The Legacy Way project (formerly known as Northern Link Road Tunnel)

Coordinator-General's report on a project change, number 4

August 2011

Figure 1.2 Proposed changed design—spoil conveyor tunnel

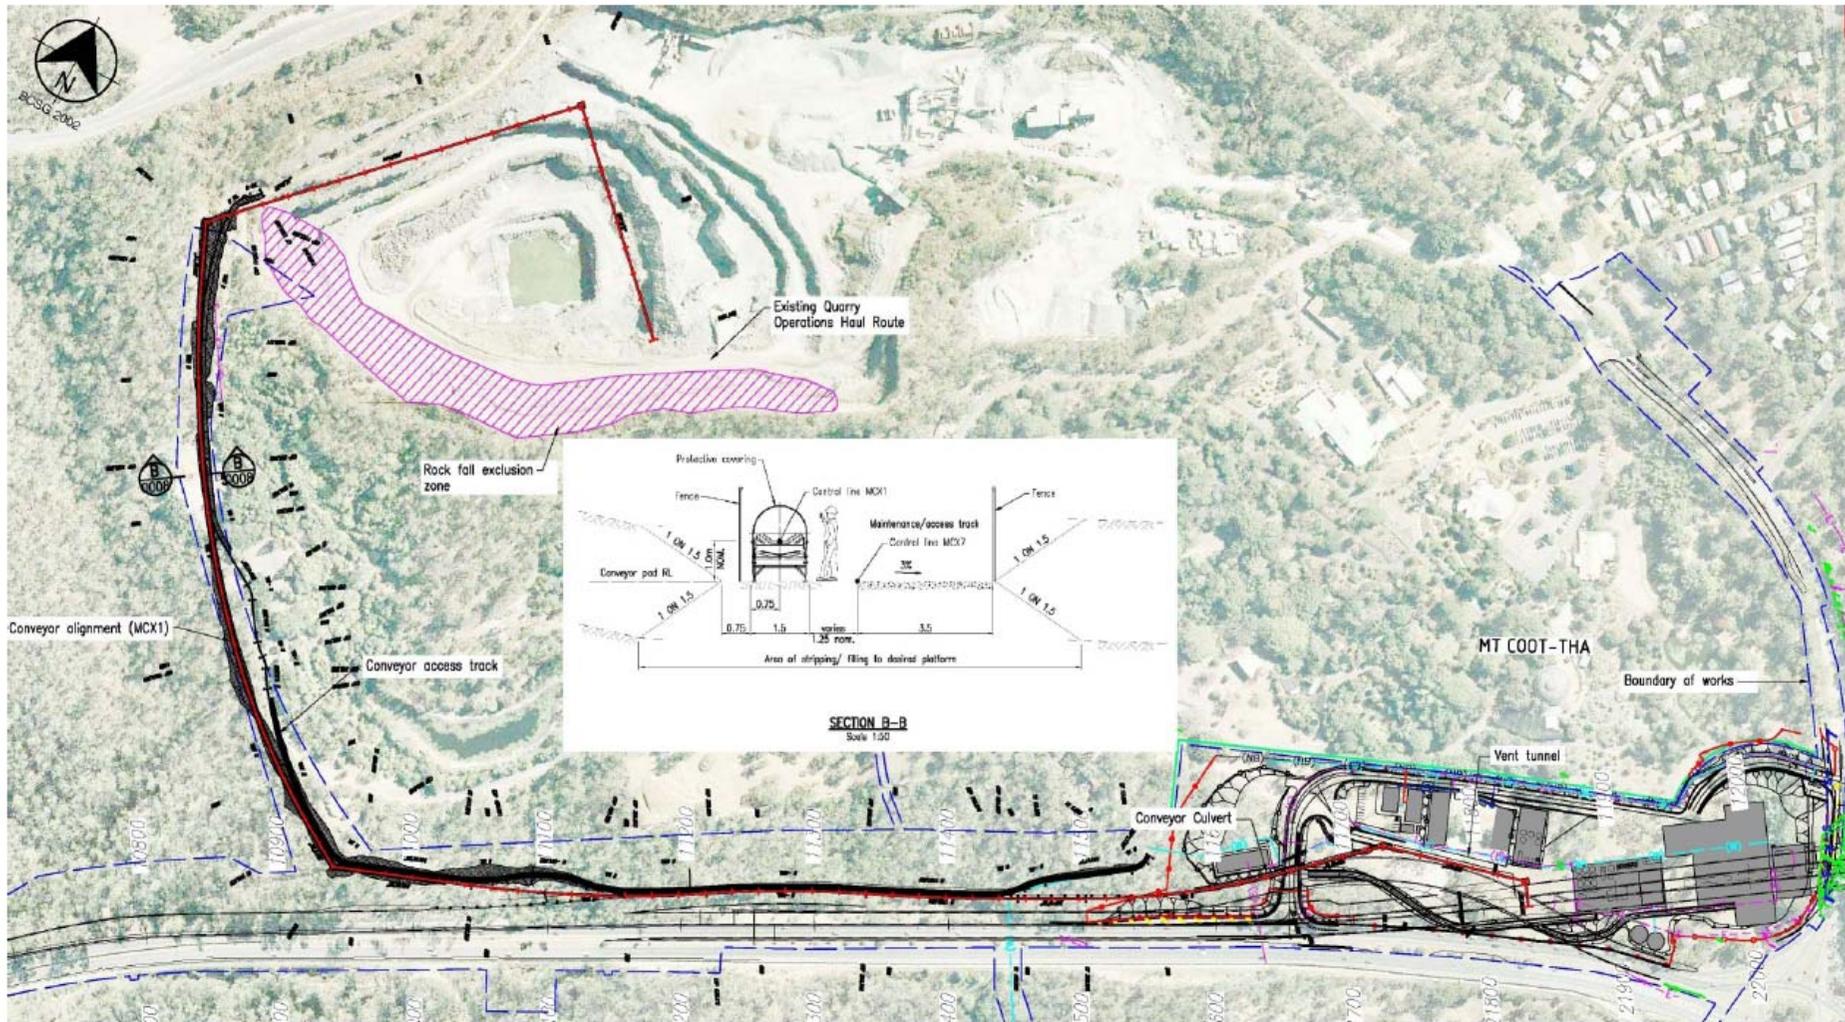
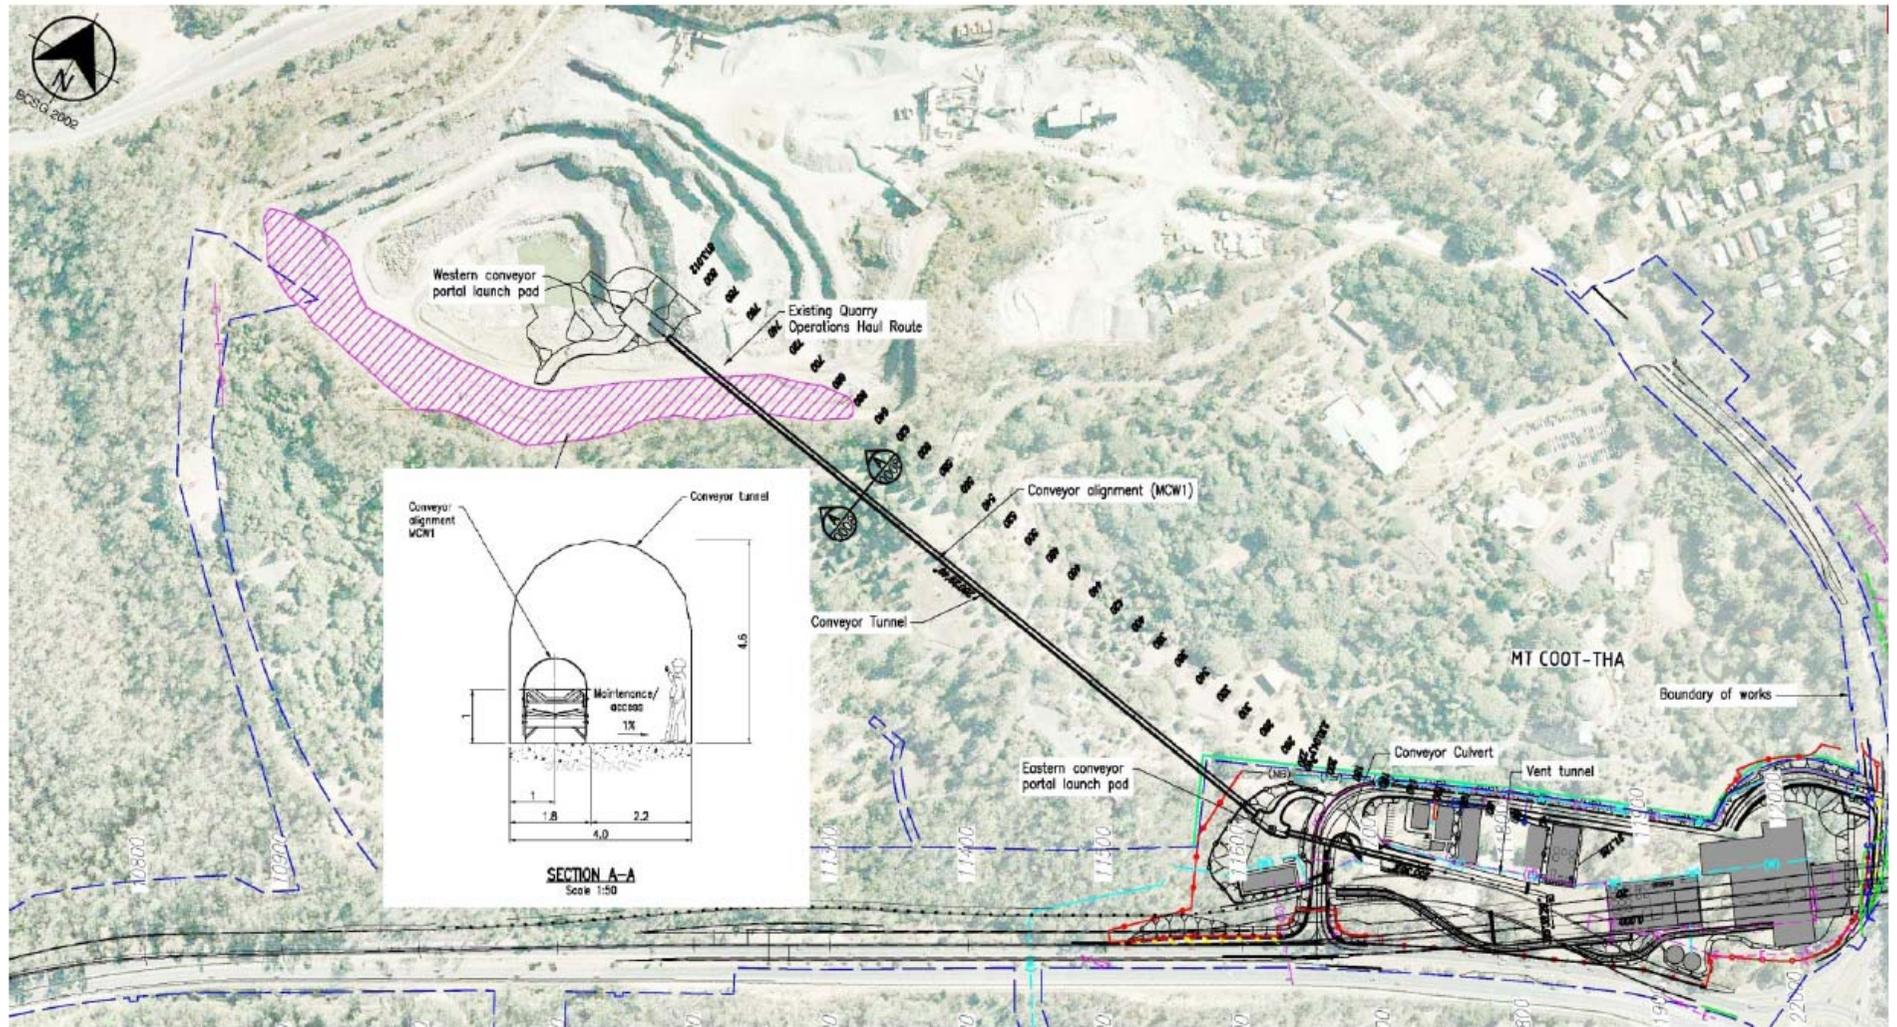
Since finalisation of the change report, Transcity has determined an underground conveyor tunnel system for spoil disposal would result in a better outcome than the over-land proposal.

Sections 5 and 6 of the APC provide details of the proposed design and construction method of the spoil conveyor tunnel. The tunnel would be around 850 metres in length, extending in a direct line from the worksite to the quarry.

The depth of the conveyor tunnel from the ground's surface varies from 11.5 metres at the entry portal in the western worksite, to a maximum depth of 52 metres as the tunnel exits at the quarry wall.

Drill and blast methods would be used to construct the tunnel, with blasting proposed to occur from October 2011 to mid-February 2012. The tunnel would be 3.5 metres wide and 4.4 metres high, which would be wide enough to drive a service vehicle alongside the conveyor system. Shotcrete will be applied to seal the crown of the tunnel and rock bolts and steel sets installed for support.

Figures 1.1 and 1.2 depict the over-land and conveyor tunnel methods.
